Application No.: 10/088,767

Title: DIRECT CURRENT MOTOR CONTROL CIRCUIT

**PETITION UNDER 37 CFR 1.181(a) TO WITHDRAW
THE HOLDING OF ABANDONMENT**

AMENDMENT AND RESPONSE TO OFFICE ACTION

Fig 1

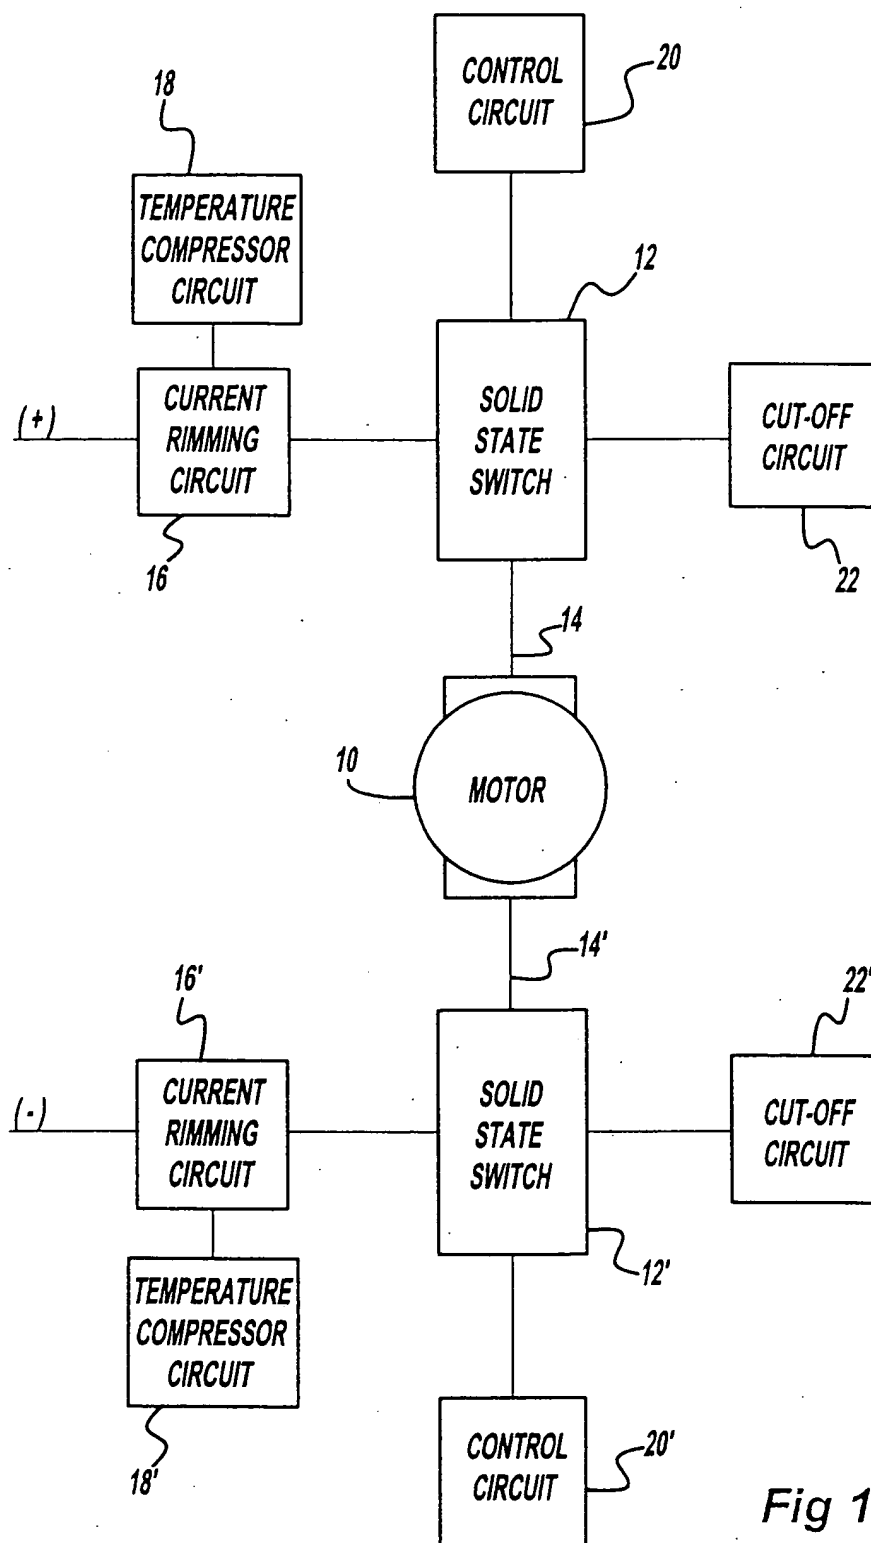
1. The drawings are objected to because fig 1 needs to be labeled descriptively. A proposed drawing correction or corrected drawings are required in reply to the Office action to avoid abandonment of the application. The objection to the drawings will not be held in abeyance.
2. Applicant is reminded of the proper language and format for an abstract of the disclosure.

The attached drawing includes changes to Fig. 1. As required by Examiner, Applicant has amended the drawings to include descriptive details. These amendments add no new matter and support for the amendments can be found throughout the detailed description section of the specification.
